UNITED STATES DEPARTMENT OF COMMERCE United States Patent and Trademark Office Address: COMMISSIONER FOR PATENTS P.O. Box 1450 Alexandria, Virginia 22313-1450 www.uspto.gov

APPLICATION NO.	FILING DATE	FIRST NAMED INVENTOR	ATTORNEY DOCKET NO.	CONFIRMATION NO.
10/772,386	02/06/2004	Junichi Tamamoto	500.43486X00	6779
	7590 12/21/201 TERRY, STOUT & KI	EXAMINER		
1300 NORTH S	SEVENTEENTH STRI	KUMAR, RAKESH		
SUITE 1800 ARLINGTON,	VA 22209-3873		ART UNIT	PAPER NUMBER
			3651	
		MAIL DATE	DELIVERY MODE	
			12/21/2010	PAPER

Office Action Commons		Application	olication No. Applicant(s)					
		10/772,386	5	TAMAMOTO, JUNICHI				
Office Action Summary			Examiner		Art Unit			
		RAKESH K	UMAR	3651				
 Period for	The MAILING DATE of this commun Reply	nication appe	ears on the	cover sheet with the c	orrespondence ad	ldress		
A SHORTENED STATUTORY PERIOD FOR REPLY IS SET TO EXPIRE 3 MONTH(S) OR THIRTY (30) DAYS, WHICHEVER IS LONGER, FROM THE MAILING DATE OF THIS COMMUNICATION.  - Extensions of time may be available under the provisions of 37 CFR 1.136(a). In no event, however, may a reply be timely filed after SIX (6) MONTHS from the mailing date of this communication.  - If NO period for reply

## Kawasaki Figure 17

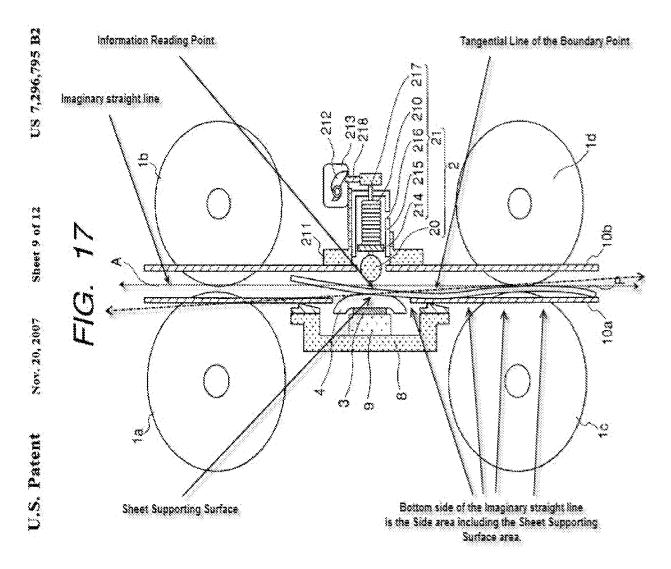
In regards to applicants arguments "when seen in a view direction that is perpendicular to the thickness direction of the sheet and the transfer direction of the sheet transfer member, a tangential line of the boundary point of the transfer surface of the sheet transfer member from which the sheet starts to separate away from the transfer surface extends in an area of an imaginary straight line passing the information reading point and the boundary point with the side area including the sheet supporting surface area. The tangential line intersects the sheet supporting surface area as seen in the view direction to press the sheet against the sheet supporting surface area." (See Figure below)

Applicant further argues "Contrary to the present invention, Kawasaki provides no disclosure or suggestion for a structure that would enable a sheet having a straight shape to be pressed against the sheet supporting surface area by the sheet transfer member when the information is read from the sheet at the information reading point in

the information reading range. Rather, Kawasaki only provides a structure wherein the sheet must necessarily be curved or bent in order to be pressed against any surface."

In view of the Office, the sheet prior to entering the apparatus of Kawasaki as shown Figure 17 and above is in a straight shape. However, once entering the apparatus the sheet is bent to be pressed against the sheet supporting surface, which is clearly shown in the Kawasaki Figure 17.

It is not clear whether the applicant is suggesting that the applicants invention does not bent the sheet in order to press the sheet against the sheet supporting surface. If this is such a case, the Office responds that the above limitations are not positively disclosed in claim 1, and further the Office suggests the applicant review the applicants drawing Figures 4-13 wherein the applicant shows a bent sheet in the apparatus and not a straight sheet.

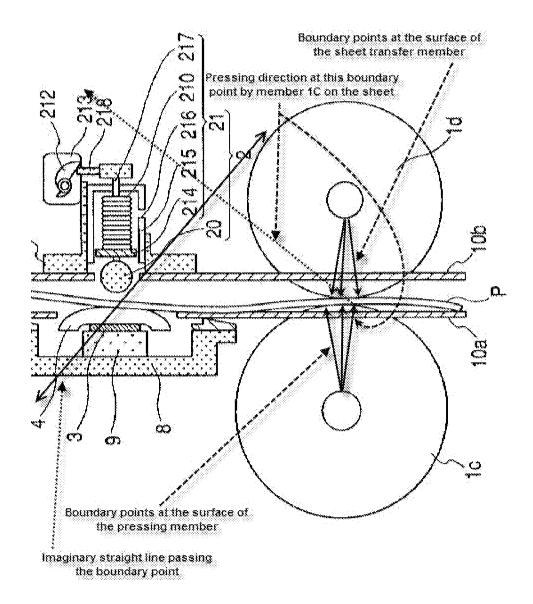
Regarding claim 9 and 27, the applicant argues "as clearly illustrated in Fig. 17 of Kawasaki, an imaginary straight line passing the boundary point in the direction perpendicular to the press direction does not intersect any of the surfaces.

Consequently, Kawasaki fails to disclose features recited in independent claim 9, such as: wherein an imaginary straight line passing the boundary point in a direction perpendicular to the press direction intersects the sheet supporting surface area," on page 17 of the Remarks.

It is to be noted, claim 9 is an independent claim therefore all limitations disclosed in the claims must be positively defined in the claim itself. In the instant case,

claim 9 recites "at a boundary point in a press direction" on line 13. The limitations "at a boundary point in a press direction" are not considered to be indefinite because "at a boundary point" is considered to be any boundary point disposed on the surface of either the sheet transfer member or the press member which in turn is in contact with the sheet. Similarly, "a press direction" is considered to be a different direction depending on which boundary point is selected thus the force vector applied to the transferred sheet by either the sheet transfer member or the pressing member will vary depending which of the boundary point is used that is in contact with the transferred sheet. Thus, the Office selects the boundary point in a pressing direction on the pressing member (1c) as shown in the Figure below and further wherein an imaginary straight line passing the boundary point. Note, the claimed limitations of claim 9 do not recite the imaginary straight line passing through the boundary point. It is in the view of the Office the limitations as recited in claim 9 are taught by the reference of Kawasaki.
